Chevron Products Company
6001 Bollinger Canyon Road
San Ramon, CA 94583
Tel 925-842-5054
Nick.Economides@chevron.com

September 6, 2017

Re: California LCFS Revisions–Comments on ARB Pre-Rulemaking Package from August 7, 2017 Workshop

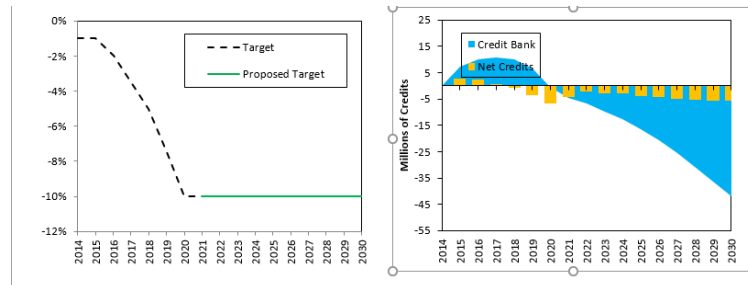
- If CI mandate held flat at 10% post-2020, the model predicts a slightly **negative credit bank** in the early 2020s even assuming a statewide 30% decrease in gasoline demand.

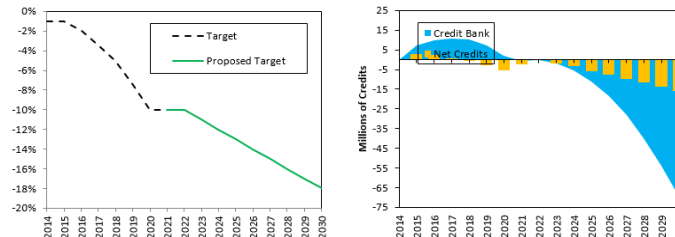
- If gasoline demand is assumed flat, with the 10% CI target held flat through 2030, the cumulative credit bank in 2030 is **negative 40 million MT**
